Structure and notation enhancements to IEEE P802.16h/D3

Paul Piggin
NextWave Broadband Inc.

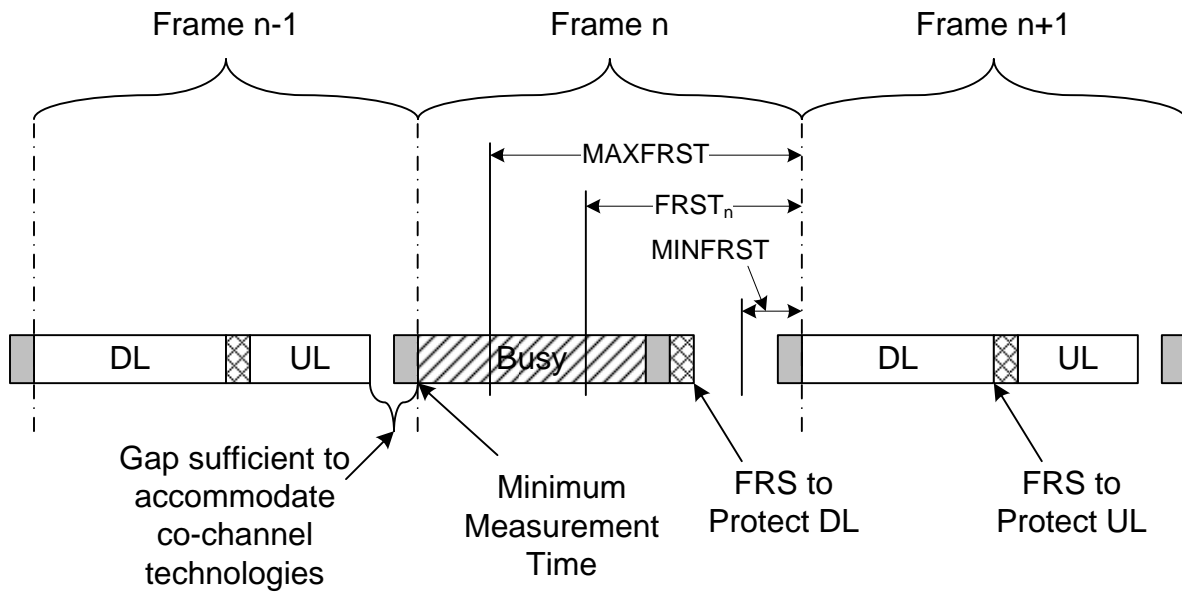
Co-channel coexistence between multiple 802.16 systems is achievable by the sharing of frames whereby advantage is derived from the synchronous behavior of 802.16. This sharing is reliant upon a known frame allocation and network synchronization. The mechanism for co-channel coexistence at the frame level is related to the band of operation, but all BS must be synchronized to GPS or NTP if GPS is not available. Situations exist where frames may be assigned to 802.16 systems by administrative means within the context of a 4 frame structure. This administrative provisioning eliminates the need to support a discovery protocol, and an a priori knowledge of frame allocation patterns. Such situations occur, for example, in bands where a regulatory requirement demands device registration together with information on device location. It is therefore possible to make use of this location information and make informed decisions on which systems should be assigned to which frames. Administrative provisioning shall therefore be used if sufficient information is available, otherwise a discovery protocol or standardized frame structure shall be used.

For the case of administrative provisioning and coexistence with asynchronous non-802.16 systems, 802.16 systems operating in a particular geographical area shall share all frames among all the 802.16 systems. The final decision to use a particular frame or not is based on channel measurements and ongoing fair sharing requirements as described in subclause 6.4.2.3.7. The remainder of this subclause describes the case where administrative provisioning is not possible. This scenario allows sharing in time of the channel by up to three different uncoordinated 802.16 systems using a four frame sequence.

Figure h19—Reclaiming the Medium Timing parameters of the DMA algorithm

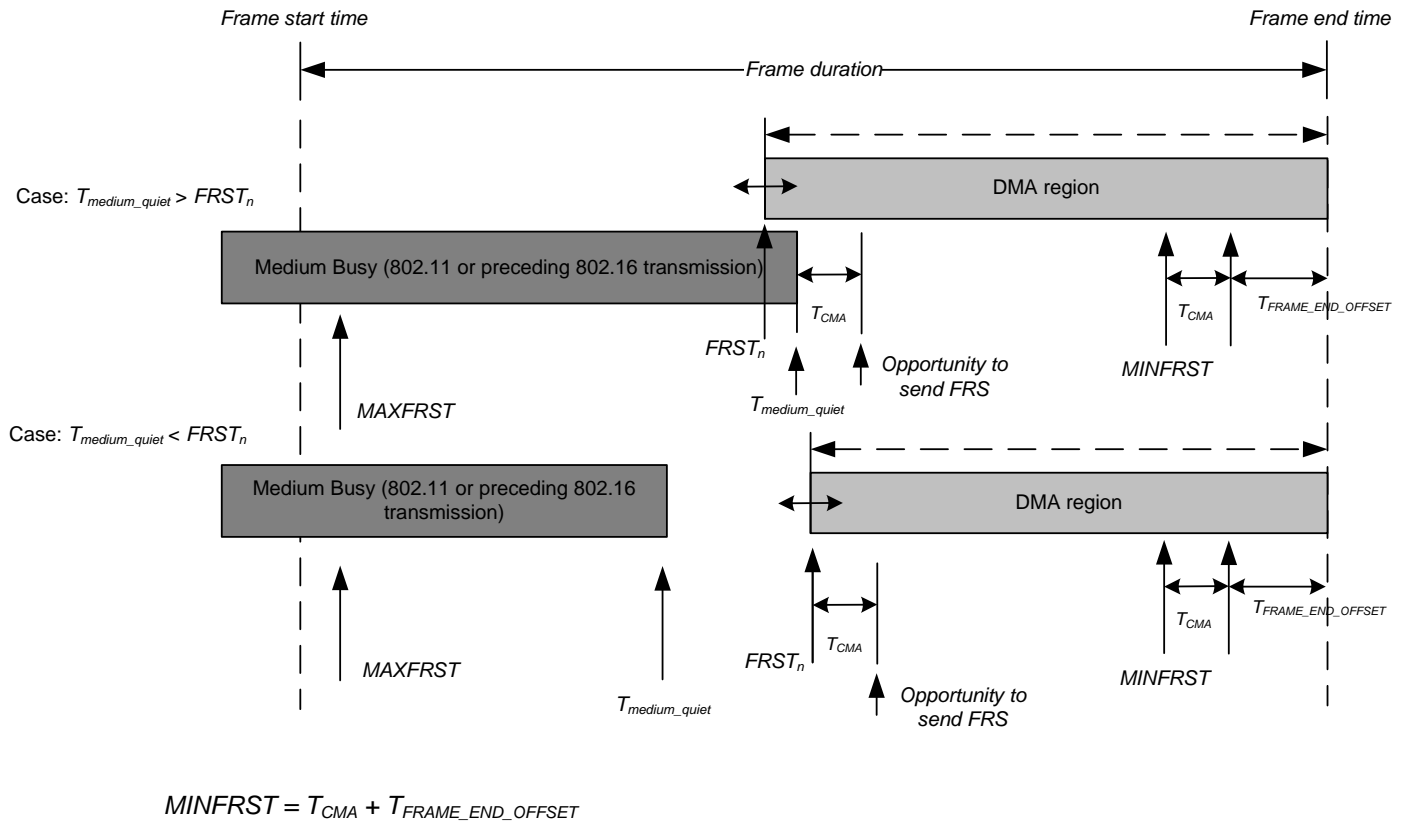
Replace Figure h19 in [1] 'Reclaiming the Medium' with the following. Also make the caption changes as shown.

The relationship between frames boundaries and the DMA algorithm is shown in Figure h x1x; tThe DMA algorithm timing parameters are applied as shown in Figure h 19.

[Figure h21 \(a\) Downlink FRS](#)

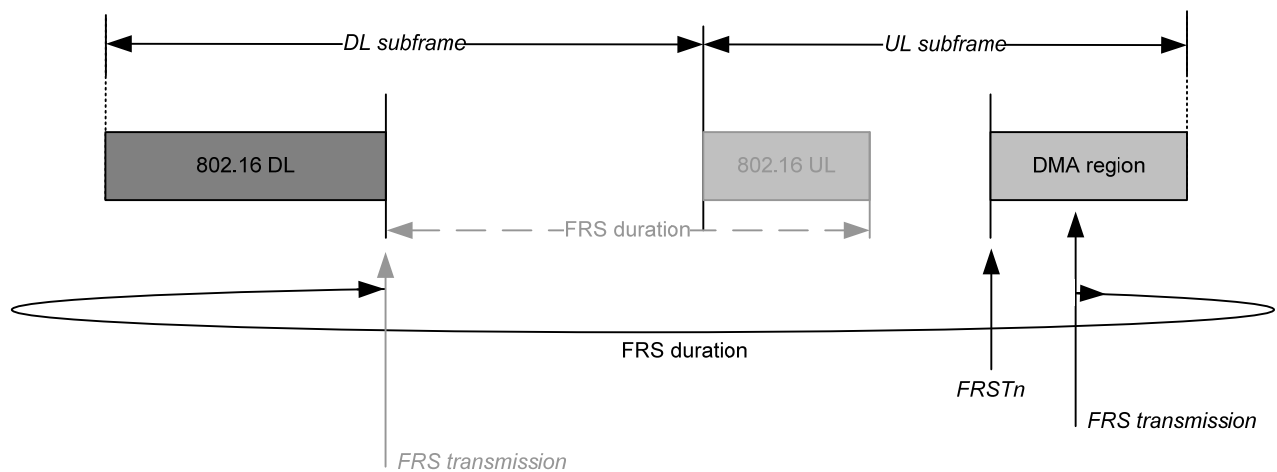
When using any carrier sense protocol, such as LBT, in a wireless environment the hidden node problem cannot be 100% avoided. It can only be mitigated. Additionally, in bands such as 3.65 GHz in the US, there is an aggravated hidden node problem due to the distinctly lower transmit power allowed for mobile devices compared to fixed, registered devices. The mobiles are more often geographically disadvantaged due to this transmit power disparity. Fixed, registered client devices can also be geographically disadvantaged (the classical hidden node problem), although not as often. To remedy this the BS transmits a Frame Reservation Signal (FRS) at the end of the DL subframe to reserve the subsequent UL subframe (or used portion, thereof) for the subscriber stations. [The BS also transmits an FRS in the DMA region at the time a decision is made to claim the medium.](#) The form of the FRS is band dependent and should be structured to be receivable by other technologies that may be co-channel. For instance, in bands where 802.11 would be a typical co-channel asynchronous system, the 802.11 CTS transmitted using the appropriate 802.11 burst structure would suffice. The reservation of the [DL and](#) UL subframe by the BTS precludes the need for the SS to also perform LBT. ~~The use of~~ [An example of using](#) the FRS to protect the [DL and](#) UL is shown in *Figure h 21*.

Replace figure h21 with the following.
